APPLICATION TO THE ZONING BOARD OF ADJUSTMENT

Denial Memorandum

RE: **23 N WARD AVENUE**
Response Letter
Block 80, Lot 11;
23 North Ward Avenue
Borough of Rumson, Monmouth County, New Jersey

CURRO RESIDENCE - REAR YARD IMPROVEMENTS

1 OF 6

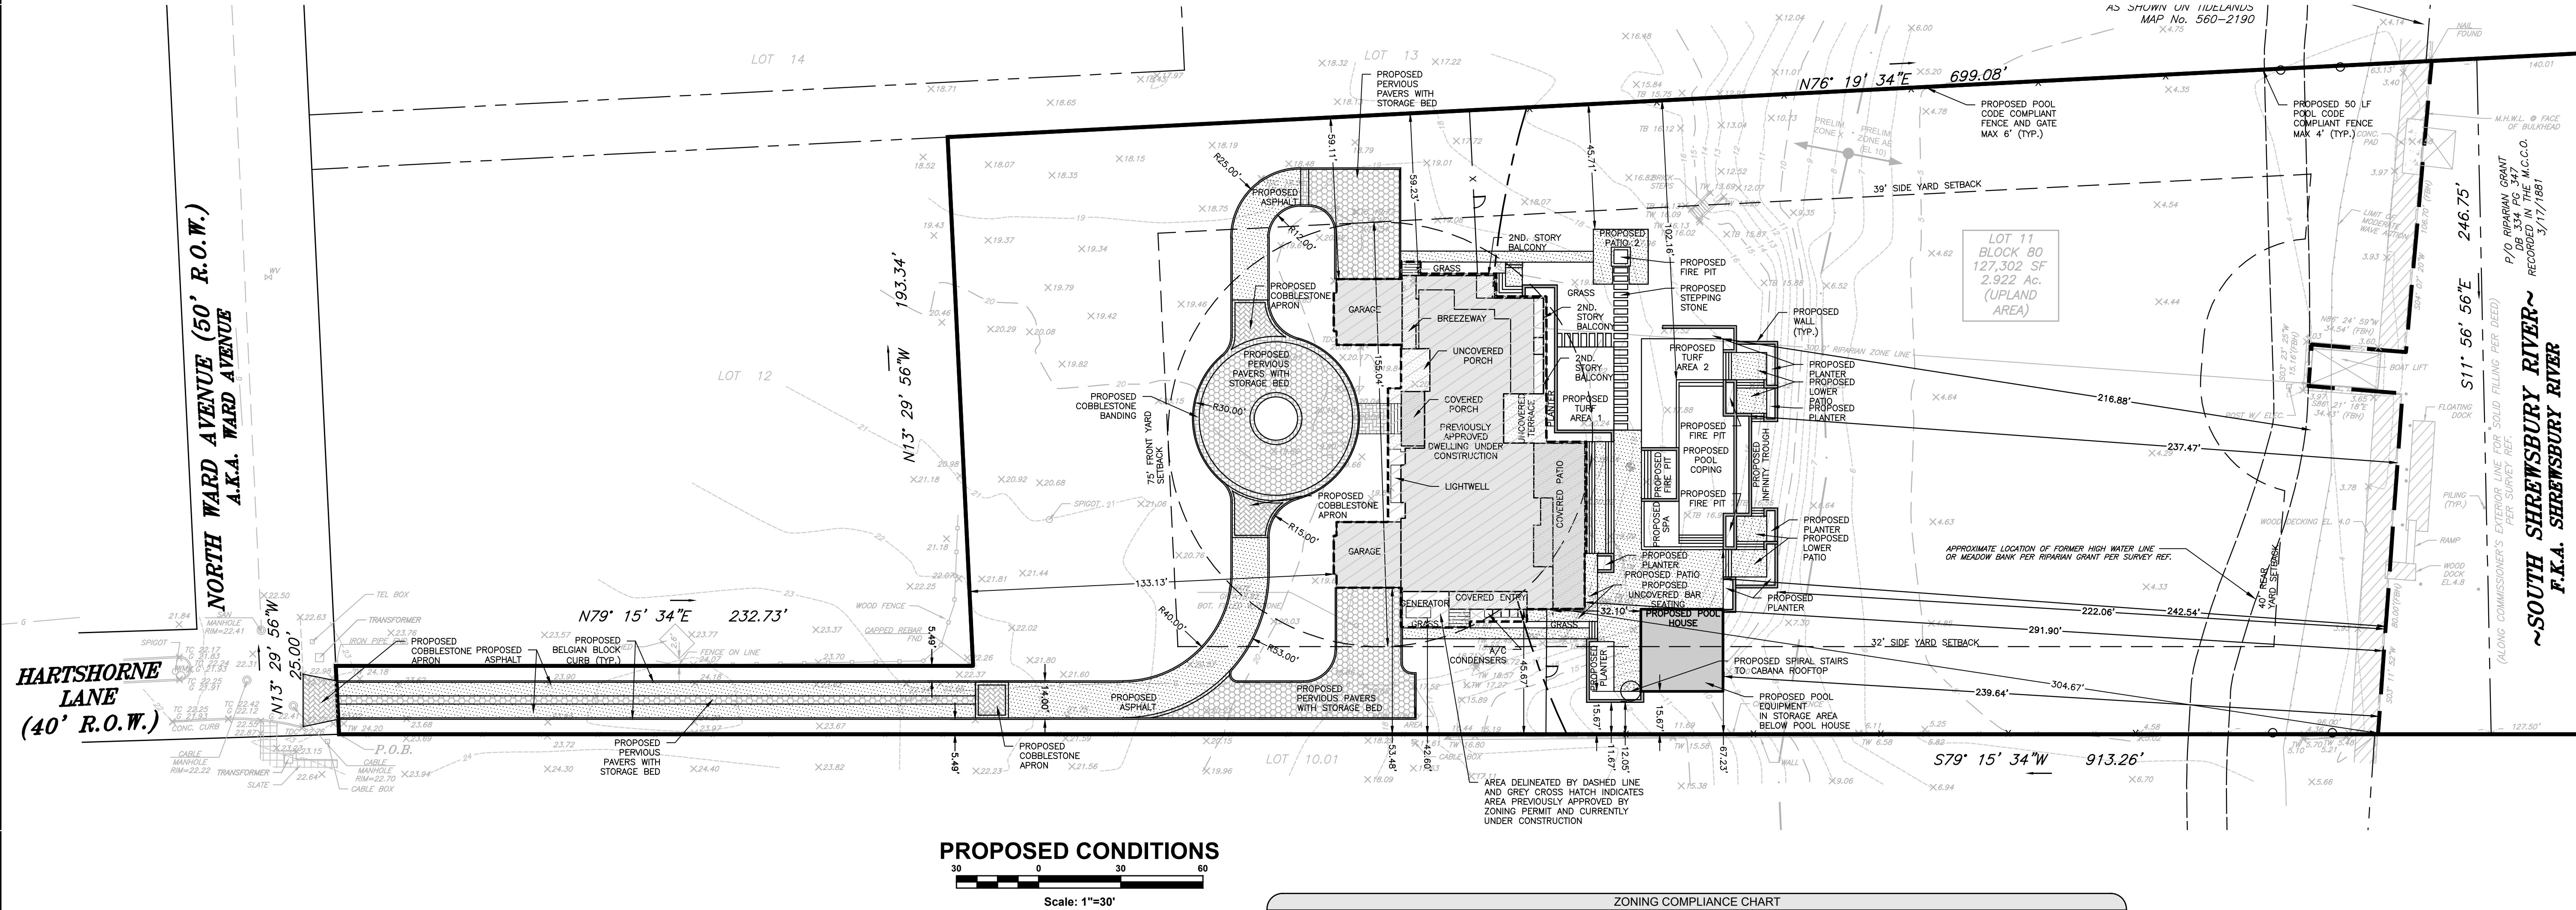
6. *Insite lot coverage calculations appear to deduct the front porch twice and at different amounts on sheet 2 of 6 (168 SF and 232 SF).*

The different totals represent the uncovered portion of the front porch and the covered portion of the front porch. The area of a covered porch can be deducted up to 10% of the principal building ground floor area. The area of an uncovered porch can be dedicated up to 30% of the principal ground floor area. Covered porches and uncovered porches are listed in different areas of the zoning schedule.

DRAWING:
A-02.00

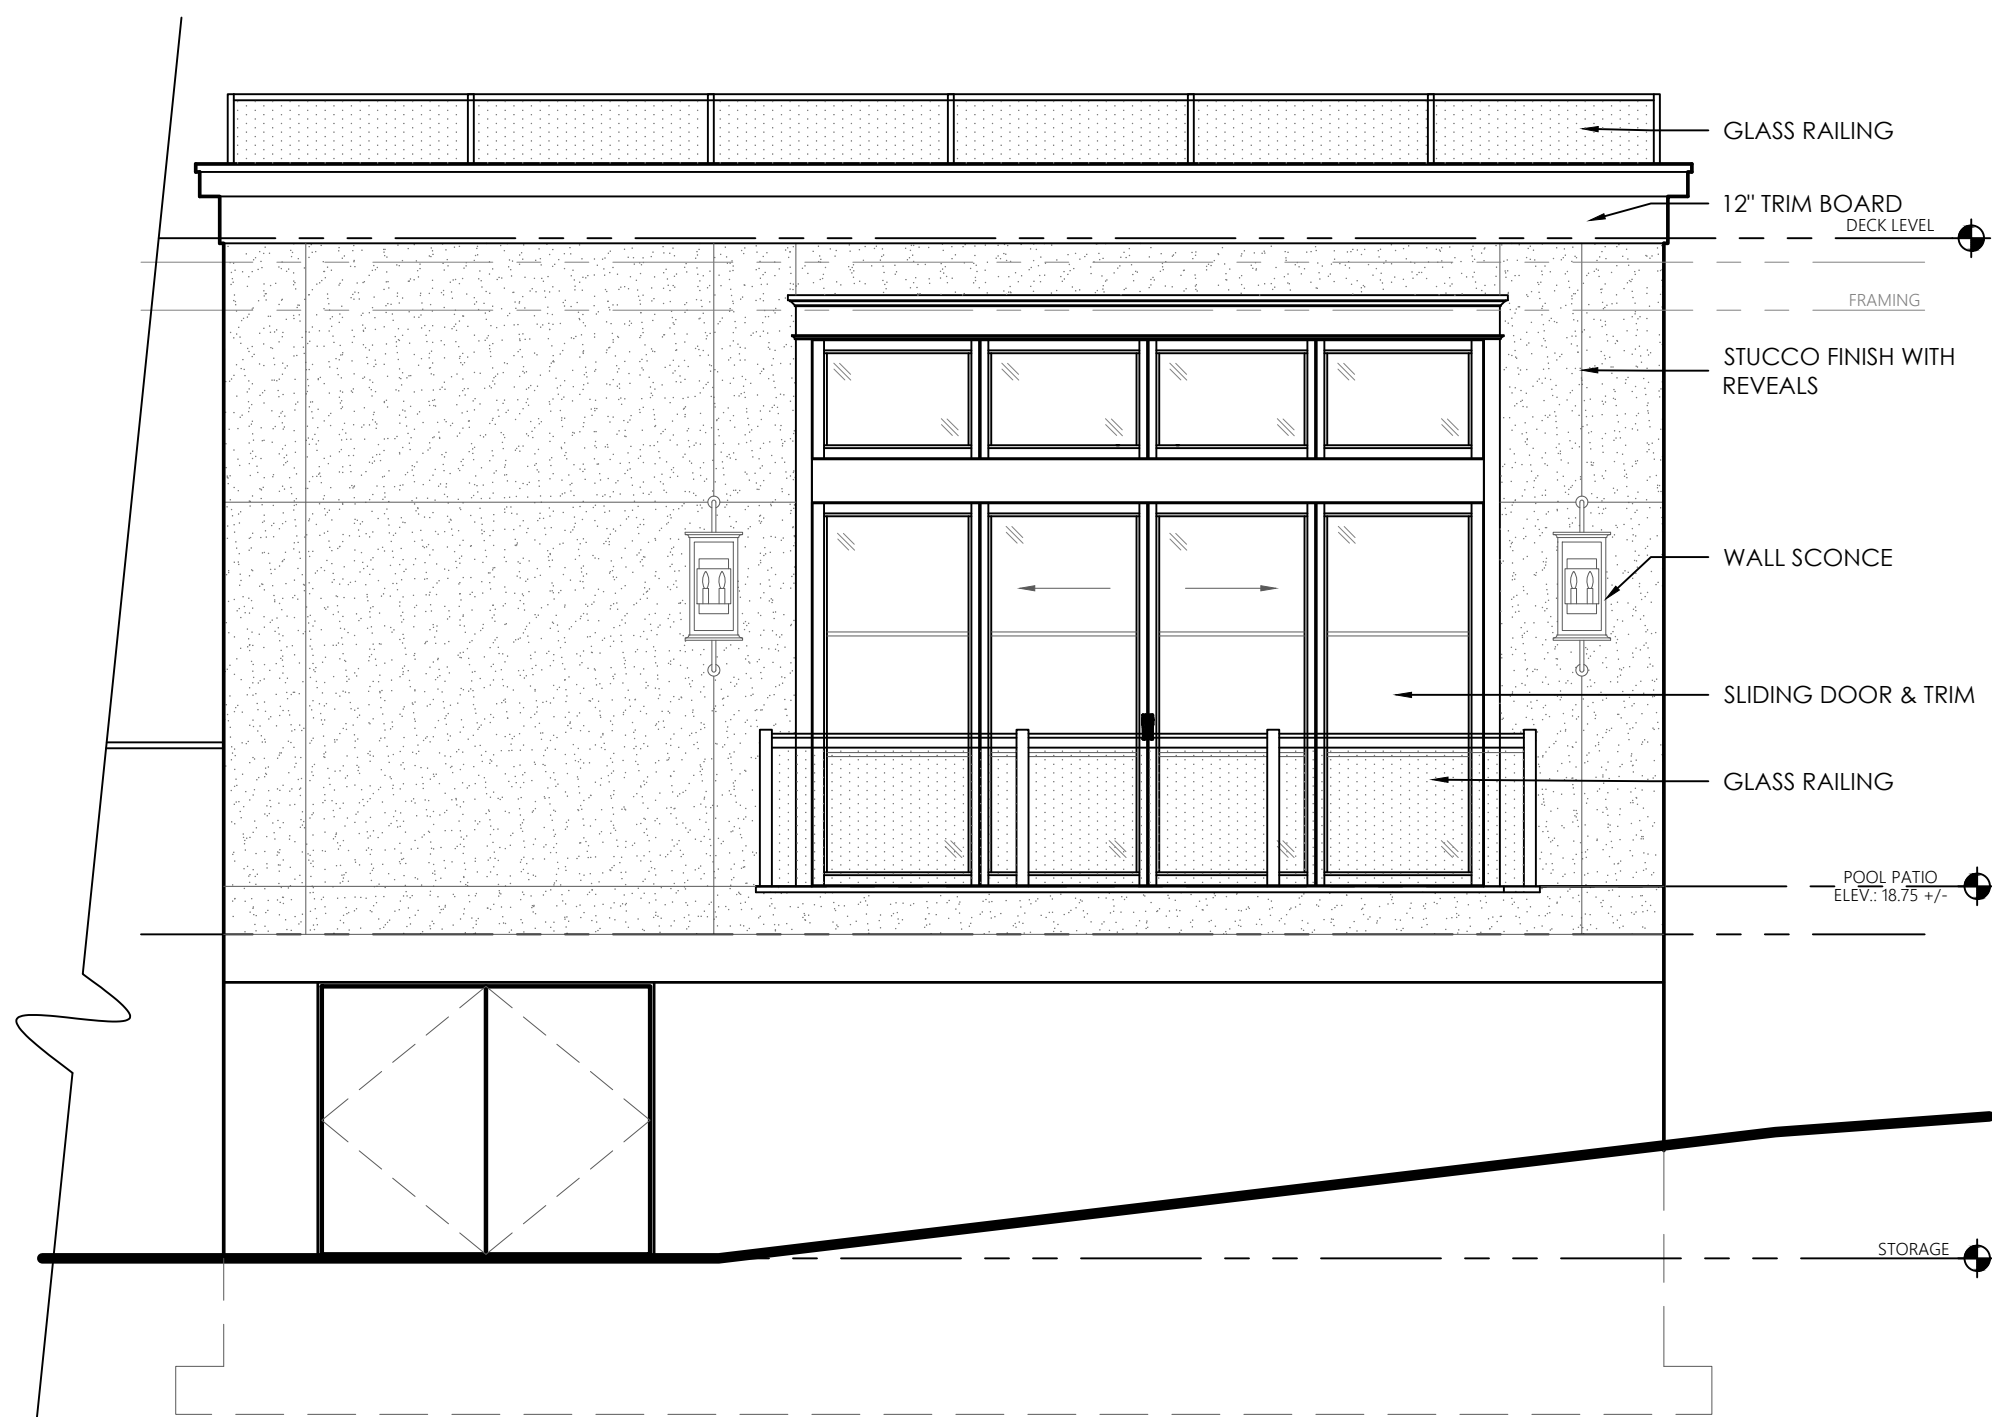
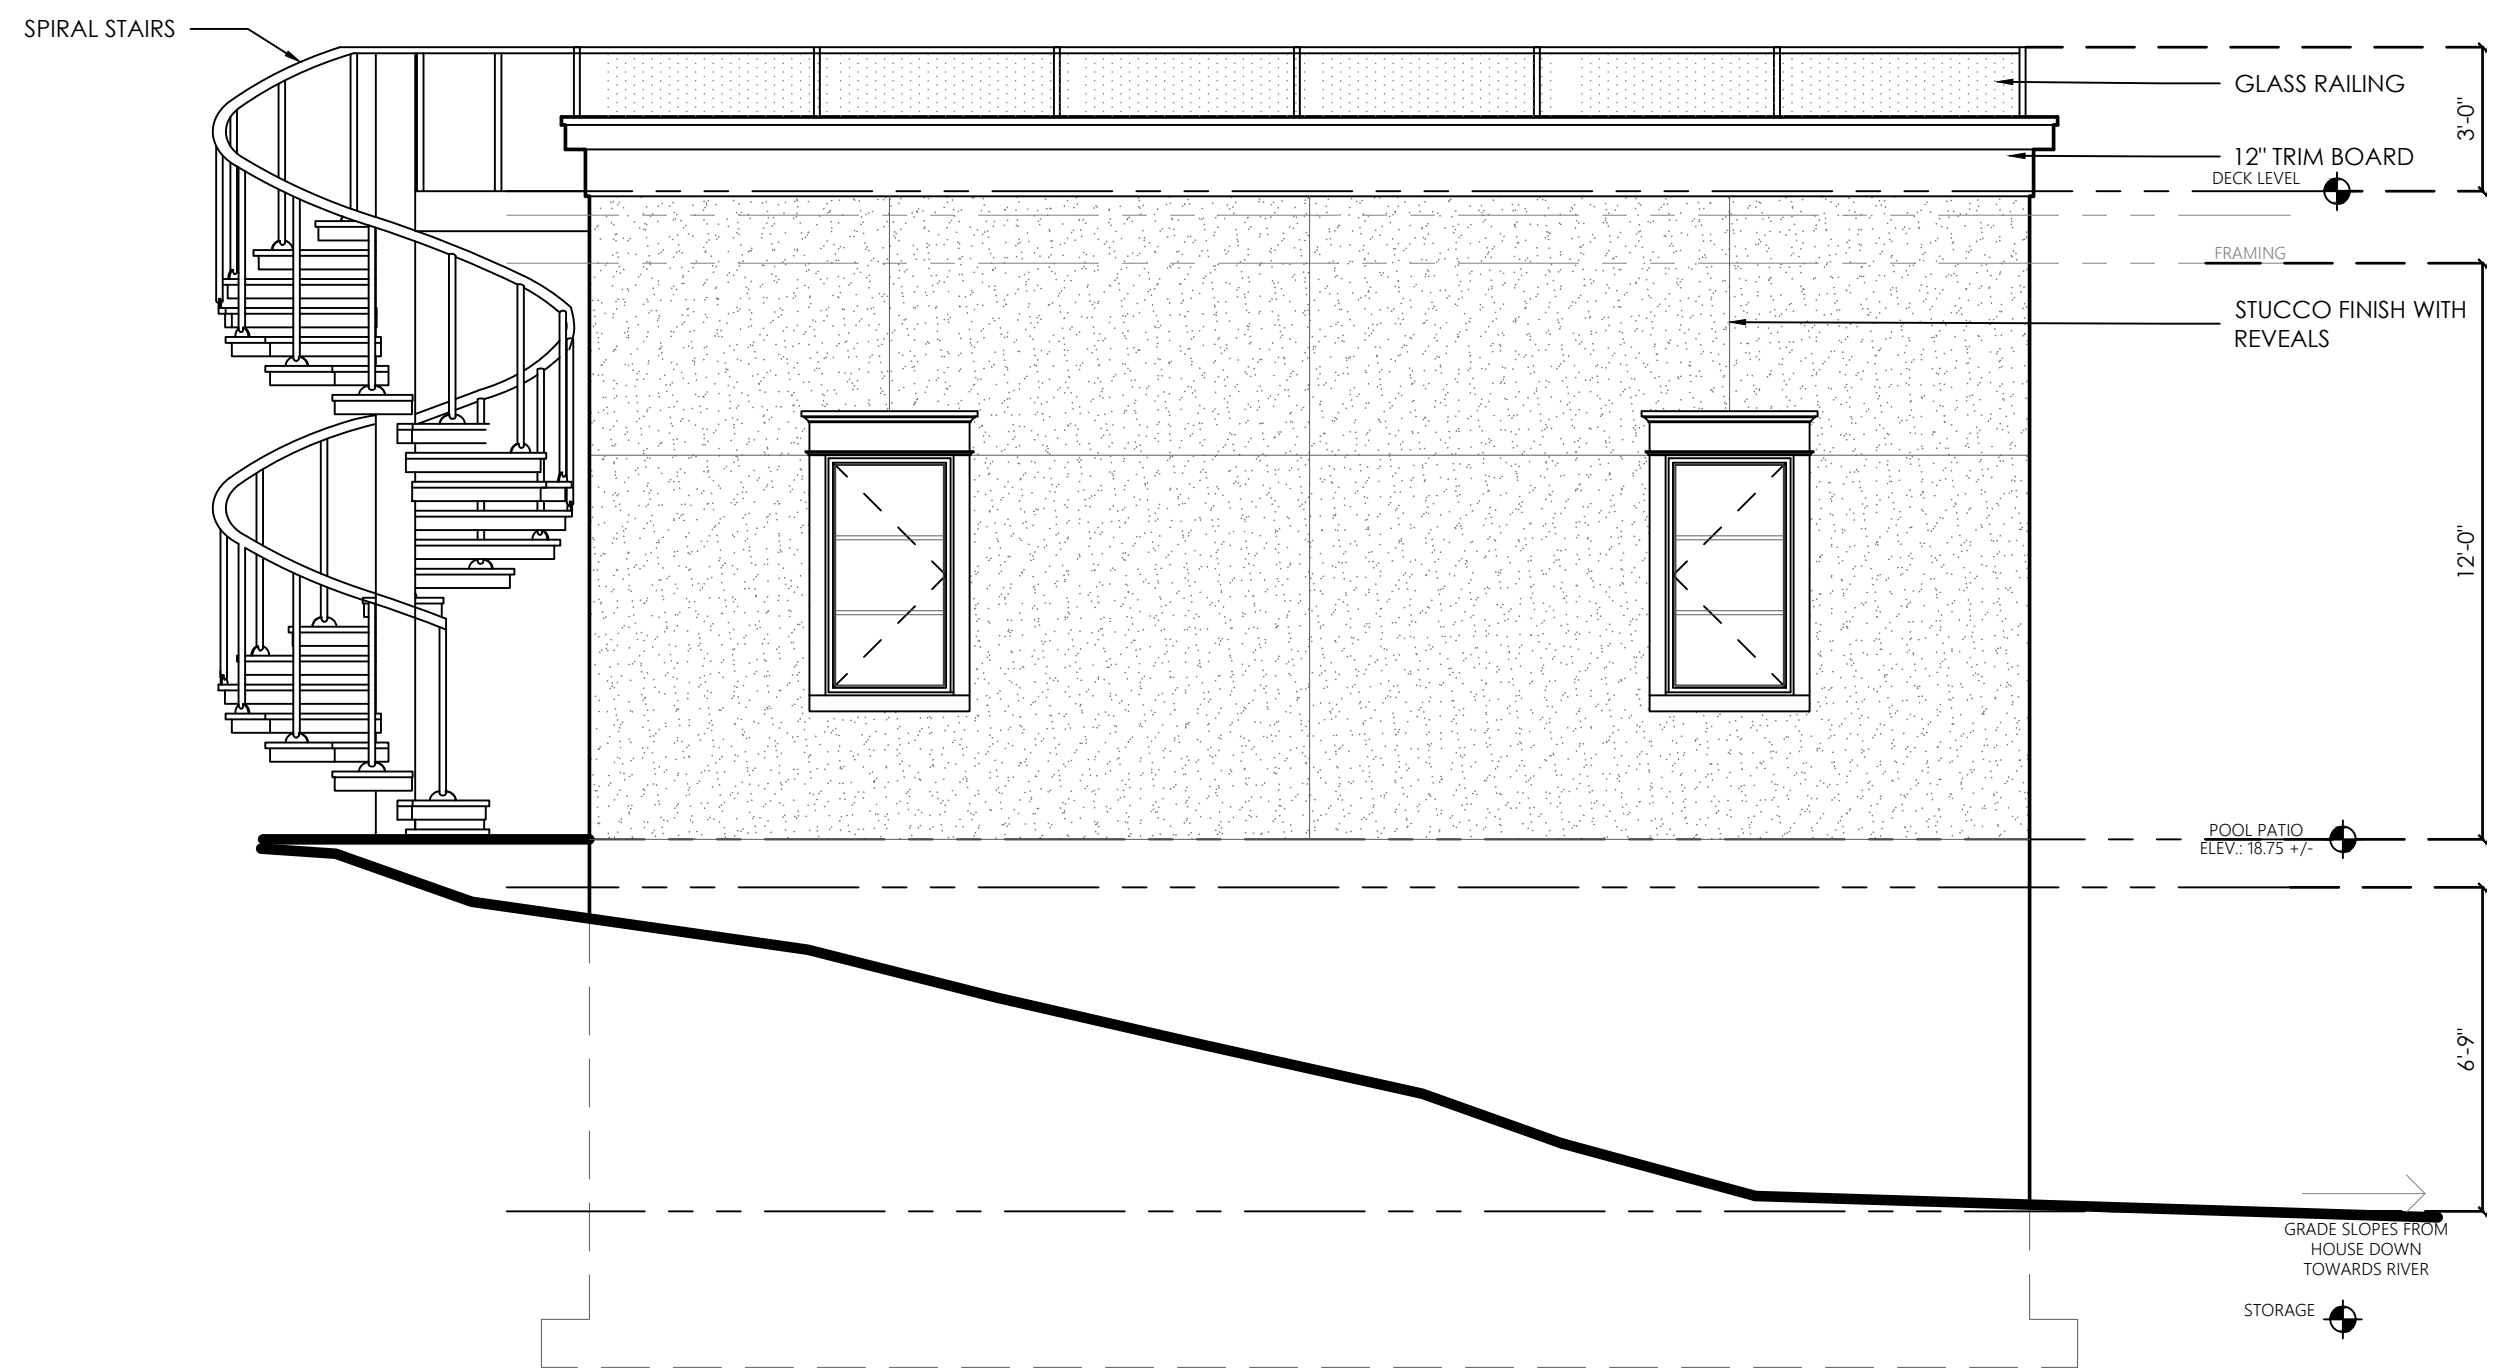
- ☐ 2. Pool House Elevations, sheet A-02.00 does not show the proposed overall dimensions from basement floor to top of glass railing on deck above the pool house.

2. *Pool House Elevations, sheet A-02.00 does not show the proposed overall dimensions from the basement floor to top of glass railing on deck above the pool house.*

Revised architectural plans are included with this submission.
